## Department of Energy

November 16, 2011

### WASTE TREATMENT AND IMMOBILIZATION PROJECT RESPONSE TO THE DEFENSE NUCLEAR FACILITIES SAFETY BOARD DESIGN OF AMMONIA CONTROLS

**Figure 1: 2001 to 2010 Wind Speed Cumulative Distribution**

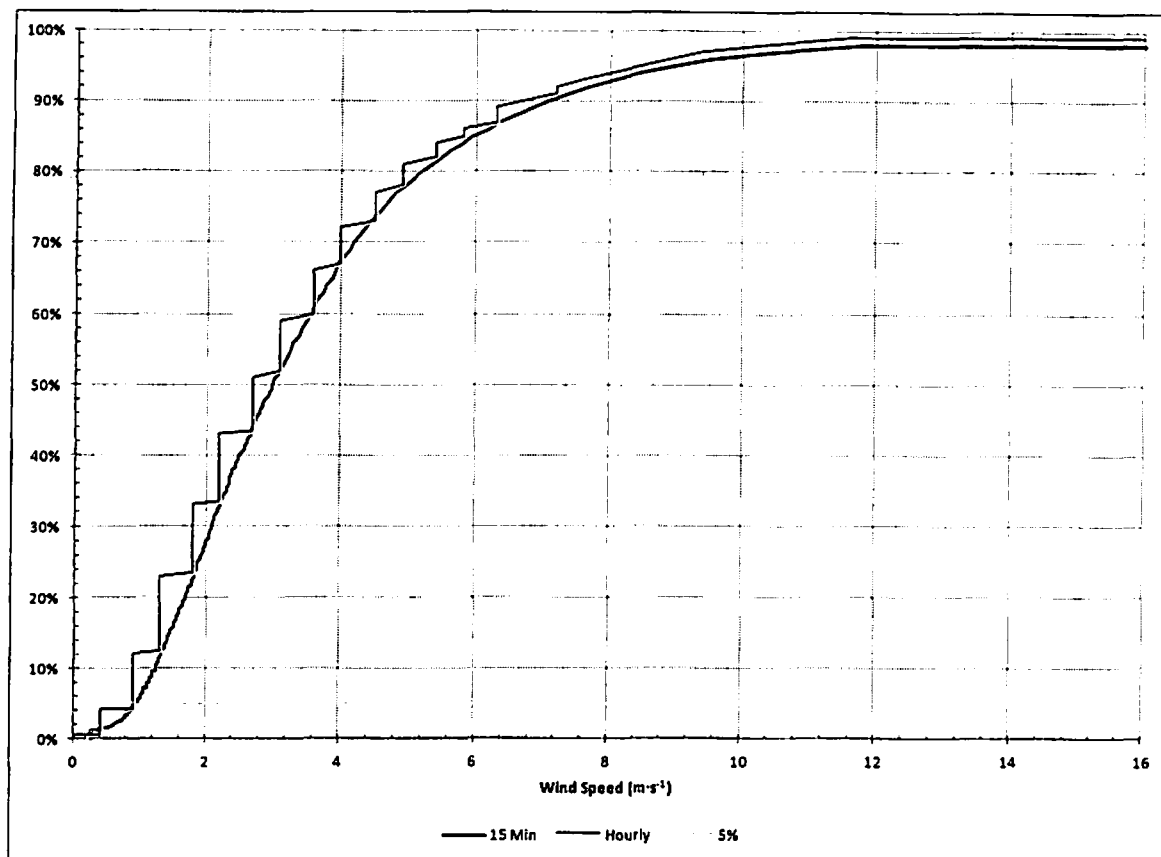
Calculation 24590-WTP-Z0C-W14T-00023 employs a puff-plume model to evaluate airborne ammonia dispersion using 10 years of hourly-averaged meteorological data obtained from the Hanford Weather Station (HWS). The Defense Nuclear Facilities Safety Board (Board) noted in its letter that because the ammonia puff duration is short, the wind speed

determined from hourly data may not be appropriate. To address this issue, the WTP has obtained 15-minute data for the last 10 years from the HWS and has determined the associated fifth percentile wind speeds. WTP has compared the 15-minute average wind speeds with those that had been based on hourly data. The results of this comparison for selected locations where ammonia releases could occur are shown in Table 1.

As can be seen, in all but one minor case, the 15-minute data yielded higher fifth percentile wind speeds, indicating that the original use of the hourly data was conservative and the one exception is on the order of a one percent difference. Because the ammonia puff release is a short-duration event, use of the 15-minute data is the more technically correct approach. Consequently, a forthcoming revision to the MCR habitability calculation 24590-WTP-Z0C-W14T-00023 will use the 15-minute Hanford 200 East Area meteorological data wind speeds for the short-term puff portion of the release. For the longer-term plume portion of an ammonia release, the hourly-averaged data will continue to be used.

The HWS determines hourly data by calculating a vector rather than a scalar average of the four 15-minute intervals in the hour, rounding the result to the nearest mile per hour. The effect of this can be seen in the cumulative distribution curve shown in Figure 1, where the rounded hourly data produces a jagged step curve that results in lower wind speeds than the smooth curve produced by the 15-minute data, and explains why data yields higher wind speeds.
